| MODEL | REV | CHANGE LIST |
|---|---|---|
| NT11 M/B BOARD | 1A | FIRST RELEASE |

| Quanta Computer Inc. | PROJECT : NT1 | PCBA NO.31MNT1MB0010 | REV :2B | DOC. NO: |

# NT1 - Block Diagram

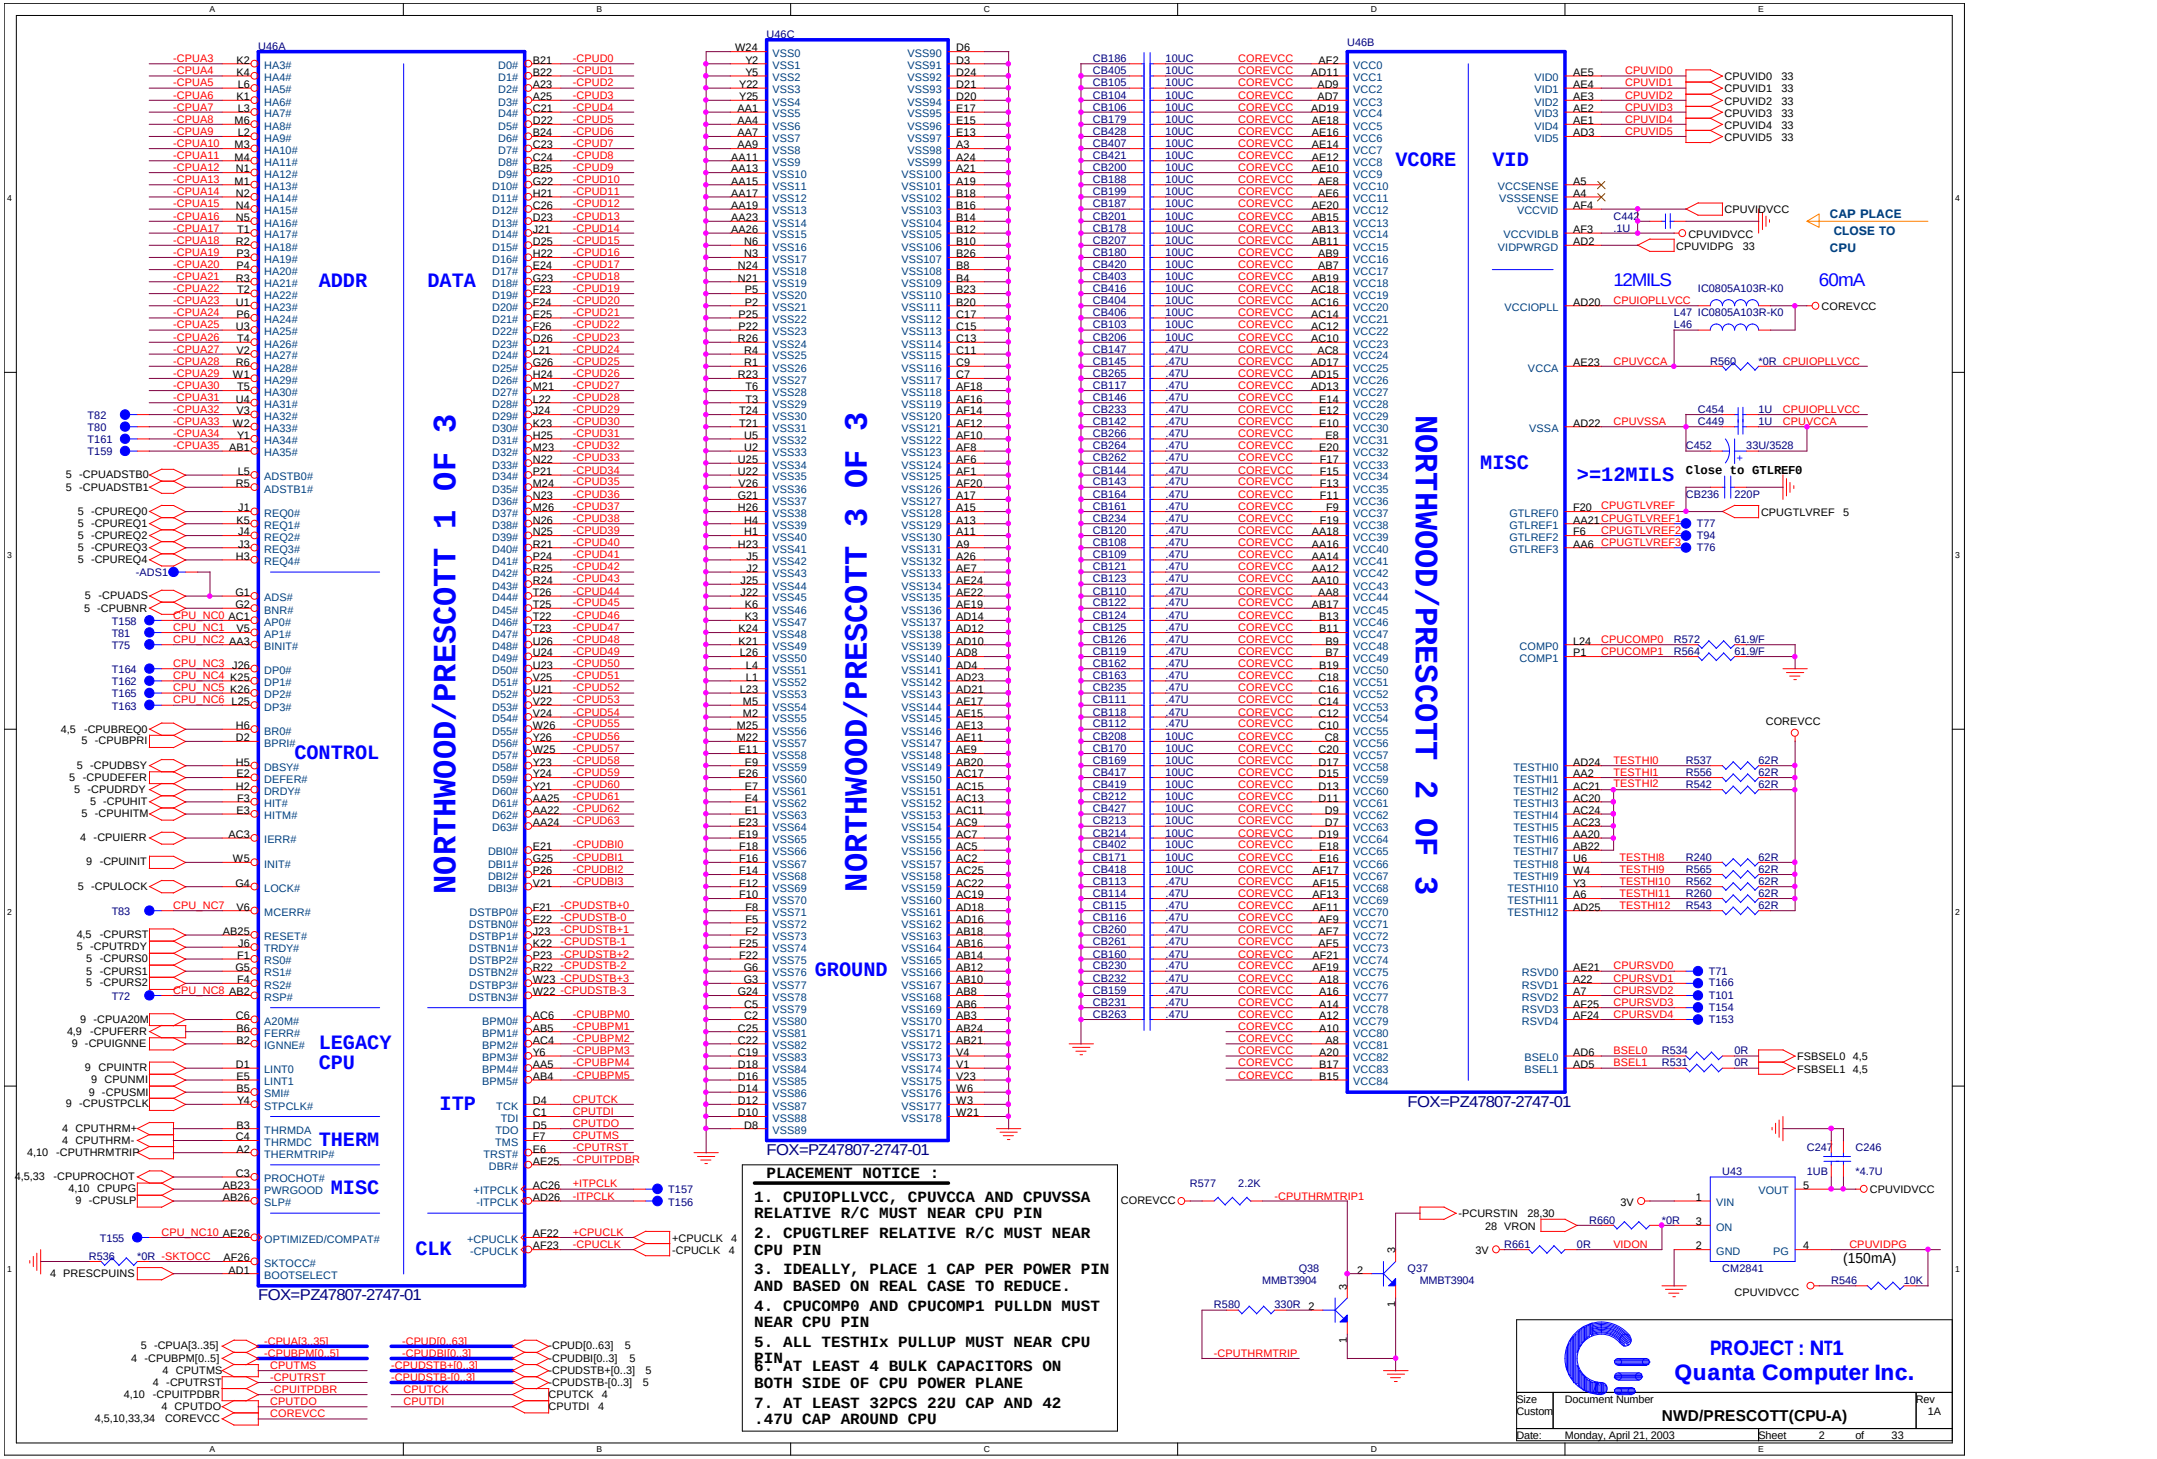
| MODEL | REV | CHANGE LIST |
|---|---|---|
| | 2A | PAGE 2 --- CHANGE R577 PULL-UP VOLTAGE TO COREVCC TO AVOID SYSTEM SHUTDOWN WHEN FIRST POWER-ON<br>CHANGE R546 PULL-UP VOLTAGE CPUVIDVCC AS INTEL CRB RECOMMANDATION<br>RESERVE 3V AS CONTROL OF CPUVIDVCC FOR THE ALTERNATIVE METHOD TO TURN-ON CPUVIDVCC<br>CHANGE L46/L47 TO 10uH INDUCTOR AS CRB RECOMMANDATION<br>PAGE 3 --- CHANGE FSBSEL0 TO PULL-UP FOR CORRECTIVE FSB DETECTION FROM CPU<br>PAGE 6 --- CHANGE ICH5 PINB3/PINC2 TO GND AS INTEL RECOMMANDATION<br>PAGE 7 --- CHANGE SODIMM DQMx SIGNAL AS CURRENT PCB REWORK. IT ALSO CAUSE SOME VTT PULL-UP DELETED.<br>CHANGE CHANNEL B SODIMM ADDRESS TO 02 AS INTEL CRB RECOMMANDATION.<br>PAGE 9 --- CORRECT RTC 32.768 XTAL FOOTPRINT<br>RESERVE 1632PG AS SUSPEND POWER WELL CONTROL PIN TO FIX FIRST POWER-ON TOO LONG ISSUE<br>PAGE 10 --- FIXED R205 TO GND FOR 8XAGP SETTING ON NV18M/NV31M<br>PAGE 15 --- CHANGE STRAPING SETTING PER NVIDIA RECOMMANDATION.<br>CHANGE LID SWITCH TO CABLE TYPE<br>INCREASE R343 TO 47K FOR PROPER LCD BACKLIGHT CONTROL<br>PAGE 16 --- CHANGE CB710 IDSEL TO AD17<br>PAGE 18 --- CHANGE 4-IN-1 FFC CONNECTOR TYPE FOR EASY INSATLLATION FFC CABLE<br>PAGE 19 --- CHANGE 1394 ISDEL TO AD18<br>PAGE 20 --- CHANGE LAN IDSEL TO AD16<br>FIXED LANVDD25 CONNECTION ERROR IN DB1 PCB<br>PAGE 21 --- CHANGE MINIPCI IDSEL TO AD19<br>PAGE 22 --- CHANGE MC7 TO 0.047U FOR NO DIAL-TONE ISSUE<br>PAGE 23 --- REMOVE R620/R626/R3223 TO IMPROVE MIC QUALITY<br>CHANGE CN8 PIN ASSIGNMENT FOR TRACE ROUTING<br>PAGE 24 --- CHANGE R263 PULL-UP TO 3V<br>PAGE 25 --- REVERSE HDD0-HDD7 PIN ASSIGNMENT FOR DESIGN MISTAKE<br>CHANGE FAN1ON/FAN2ON TO FIX FAN NOISE ISSUE<br>REMOVE ALL FAN3 RELATIVE COMPONENT<br>PAGE 26 --- CHANGE ALL BUTTON SWITCH TYPE FOR M/E LIMIATION<br>ADD 2 EXTRA POWER-ON LEDS AND BUFFERS<br>CHANGE Q23 TO 2N7002 FOR DRIVING ISSUE<br>CHANGE CN1 CONNECTOR TYPE FOR M/E LIMIATION<br>PAGE 27 --- CHANGE K/B FFC CONNECTOR TYPE FOR EASY INSTALLATION<br>CHANGE U48 FOOTPRINT TO FIX LAYOUT MISTAKE<br>RESERVE PR8 FOR MX0-MX7 PULL-UP<br>PAGE 28 --- ADD PD33/PD34 FOR CABLE DOCK DESIGN<br>FINE-TUNE PR148/PR60 FOR BATTERY CHARGER<br>PAGE 29 --- ADD Q51 FOR LAN POWER CONTROL<br>PAGE 32 --- CHANGE PR123/PR128 FOR CORRECT COREVCC SENSE |

| Size | Document Number | Rev |
|---|---|---|
| Date: Monday, April 21, 2003 | Sheet 10 of 33 | |

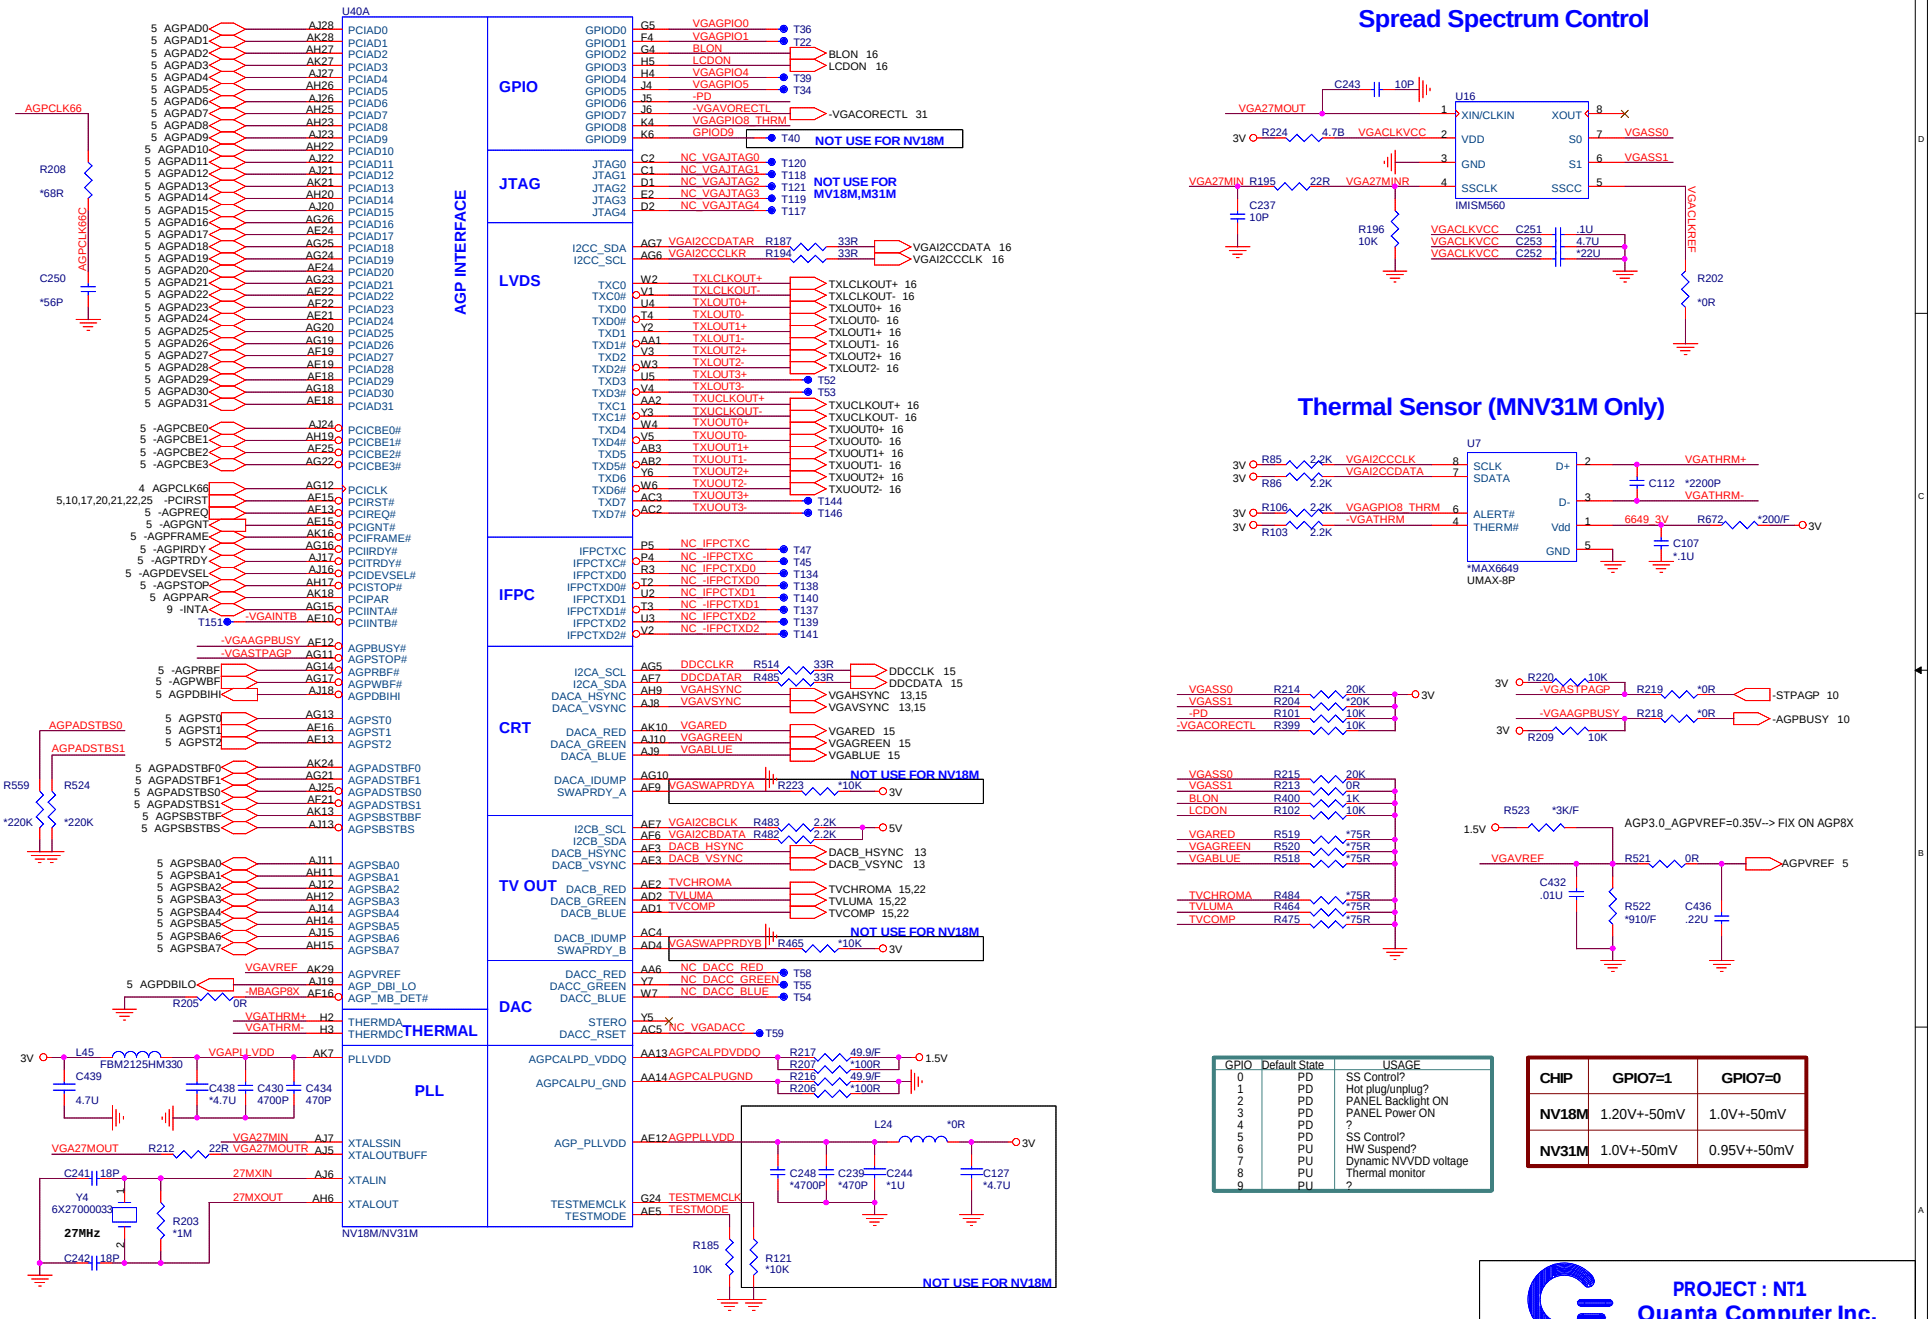
| MODEL | REV | CHANGE LIST |
|---|---|---|
| | 3A | PAGE 3 --- ADD 200ohm resistor on thermal IC power pin (Maxim recommand)<br>PAGE 4 --- Change some SPD VGA pin to GND as INTEL design guide.<br>PAGE 10 --- Change VGA thermal IC to MAX6649 (nVidai recommand).<br>PAGE 15 --- Reserve VGA2.5V discharge circuit.<br>PAGE 27 --- Reserve -LID pin also routing to EC. (SW request)<br>PAGE 28 --- Change PR16/PR100 value for charger function. |

| Size | Document Number | Rev |
|---|---|---|
| Date: Monday, April 21, 2003 | Sheet 11 of 33 | |

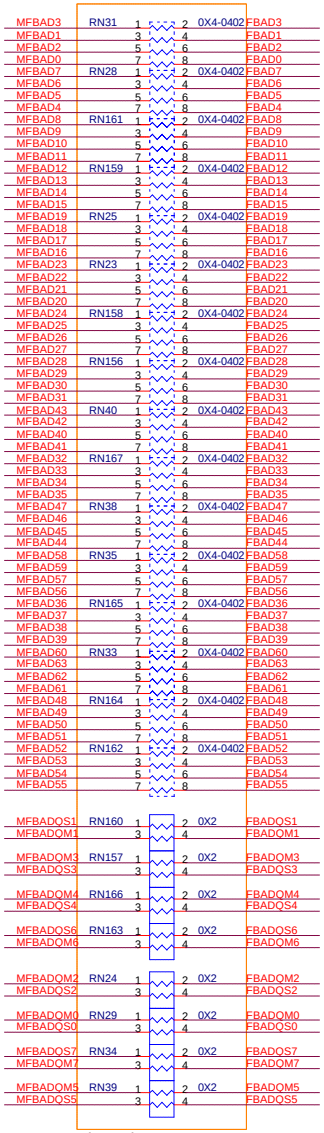
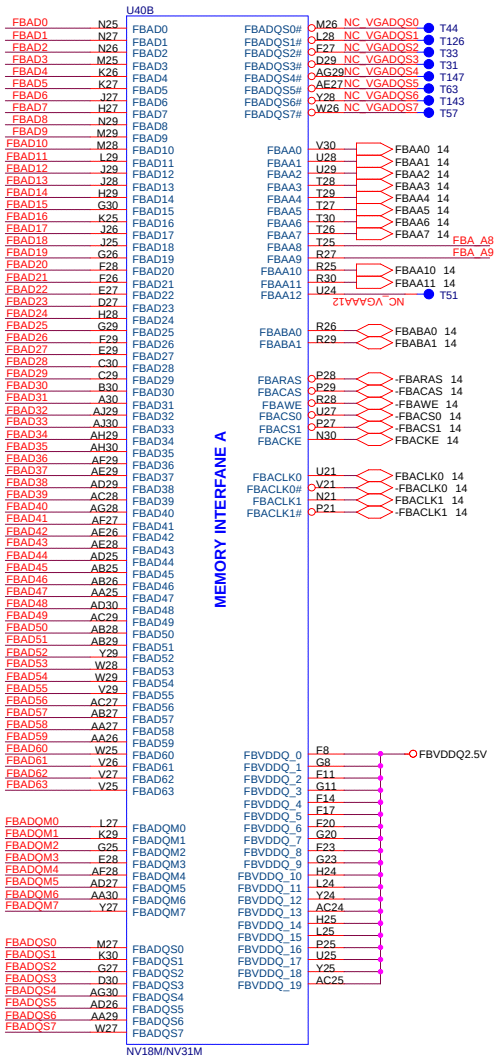
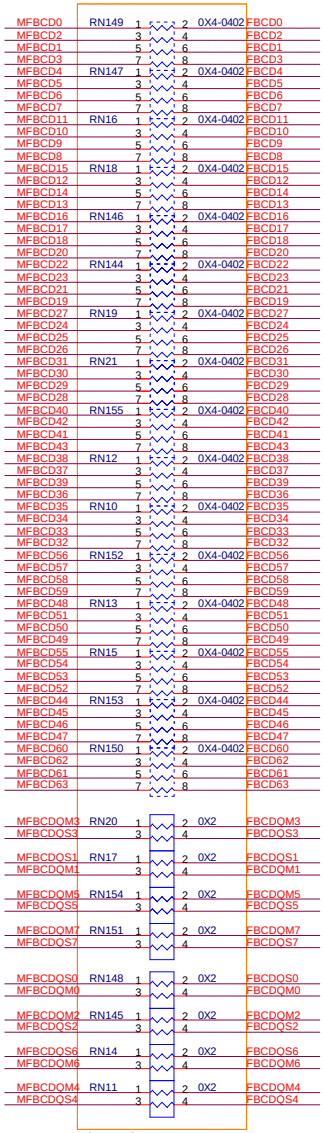
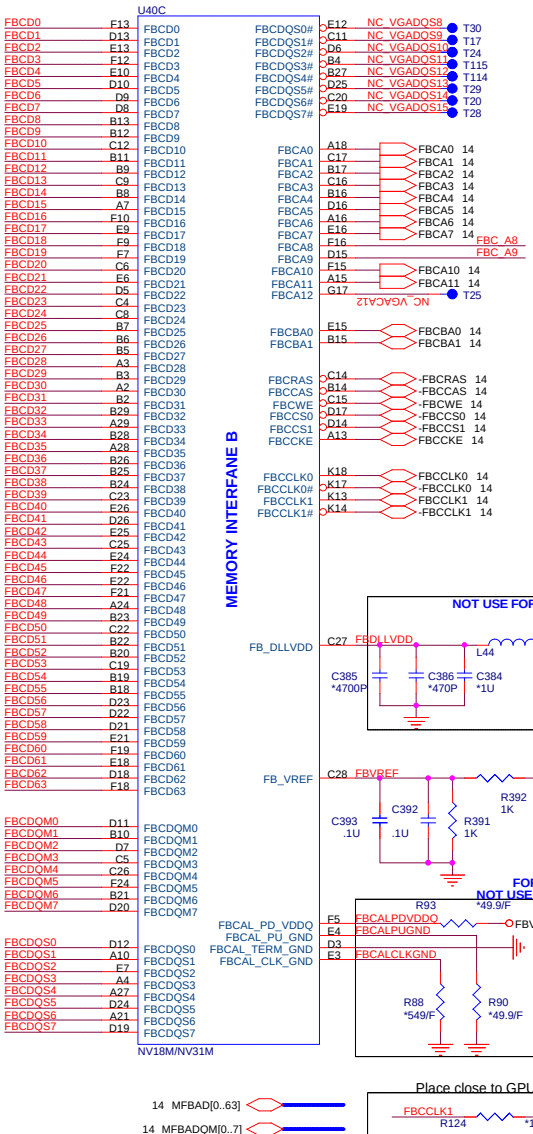
| MODEL | REV | CHANGE LIST |
|---|---|---|
| NT11 M/B BOARD | 4A | PAGE 11 --- ADD 2ND CHIP SELECT TO SUPPOT TWO CS TYPE 8Mx32 DDR VRAM. ADD NV31M PIN P27 AND D14 TO VRAM FOR2ND CS.<br>PAGE 12 --- THE STRAPPED PINS NEED TO CHANGE FOR TWO CS TYPE VRAM; TO BE CONFIRMED BY NVIDIA. (TO BE CONFIRMED)<br>PAGE 13 --- ADD 2ND CHIP SELECT TO SUPPOT TWO CS TYPE 8Mx32 DDR VRAM. ADD VRAM PIN L3 AS 2N CS.<br>PAGE 26 --- INCREASE USB PORT POWER FROM 0.5A TO 1A TO SUPPORT USB HDD DEVICE. SHORT U33/U34 PIN 5 AND 8 TO INCREASE POWER.<br>PAGE 28 --- CHNANGE BAT-IN INDUCTOR TO AVOID ME INTERFENCE IN SI1 UNIT. USE 2 FBMJ3216HS480 TO REPLACE FBMH453281-T.<br>PAGE 29 --- ADD VGA2.5 DISCHARGE CIRCUIT TO MEET NVIDAI POWER SEQUENCE. ADD PQ74, PQ74, R172 AD R172 TO CONTROL DISCHARGE TIME.<br>PAGE 30 --- FINE TUNE VGACORE CIRCUIT.<br>1. CHNAGE PU1 FROMLM358 TO LMV321. (POWERED BY 5V)<br>2. CHANGE PR1 FROM 10K TO 4.7K AND ADD PR173 4.7OHM RESISTOR TO IMPROVE RESPONSE TIME.<br>3. CHANGE PC80 BULK CAPACITOR FROM 100U TO 330U FOR BIG CURRENT.<br>4. ADD PC175 100PF TO FLTER HIGH FREQ NOISE. |
